RESPONSE LETTER NO. 1 TO REQUEST FOR INFORMATION

Project Title: **Metrorail 3rd Rail Isolation Disconnect Switch Replacement**
Project No.: **IRP338-DTPW23-CT**

TRACTION POWER EQUIPMENT INSTALLATION
 PALMETTO YARD ELECTRIFICATION SYSTEM
 1000V DC DISCONNECT SWITCH
 CABINET LAYOUTS

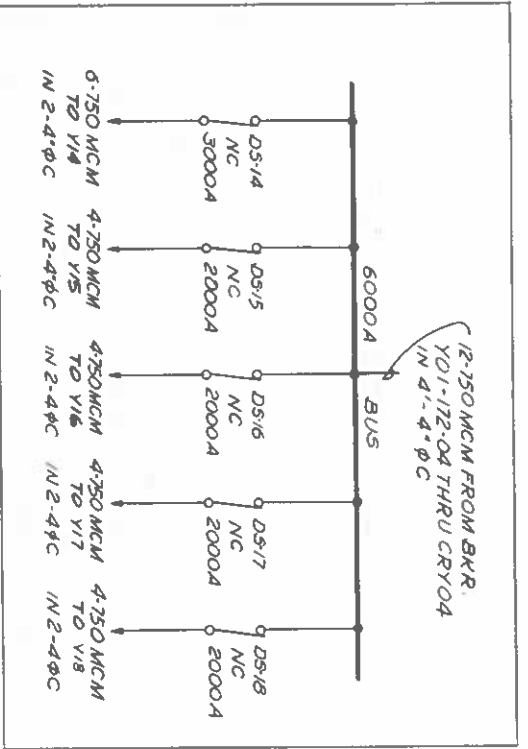
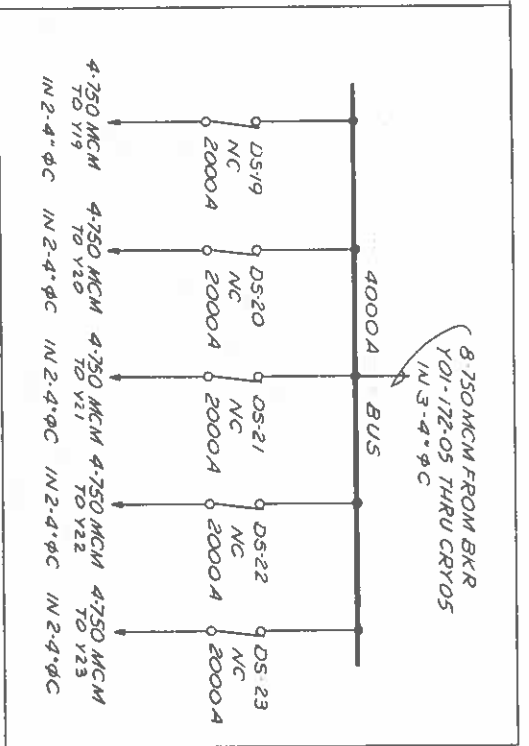
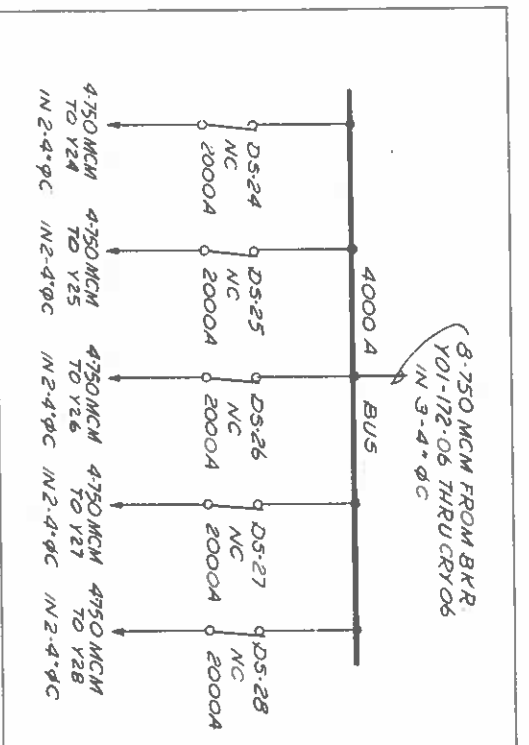
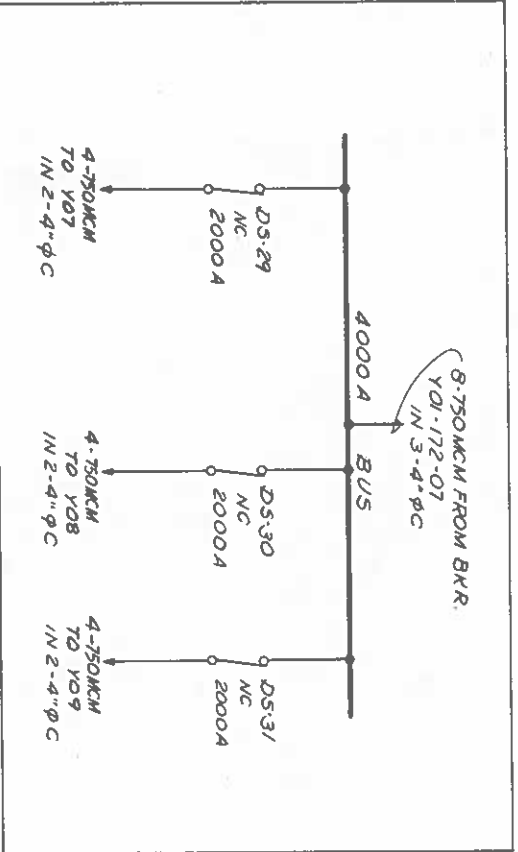
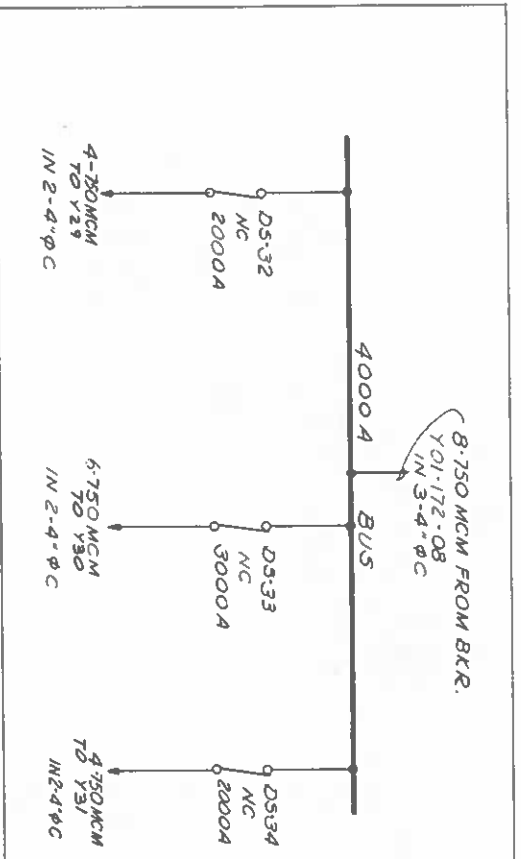
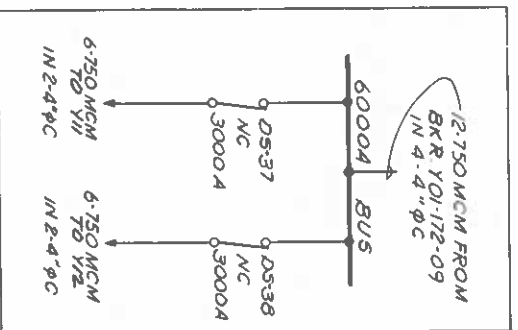
QUESTION No.1: Several switchgear vendors have stated that there is not enough information to be able to price the new switches and PLC's Will there be any drawings provided for this bid other than the diagrams in addendum 1.

QUESTION No.2: The specifications indicate that the new disconnects and other equipment need to be compatible with existing equipment. Is it possible to get any as-built drawings or information on the existing equipment we need to be compatible with?

ANSWER No.1: See attached diagrams. The specs for the PLCs are in the contract.

ANSWER No.2: See attached diagrams herein.
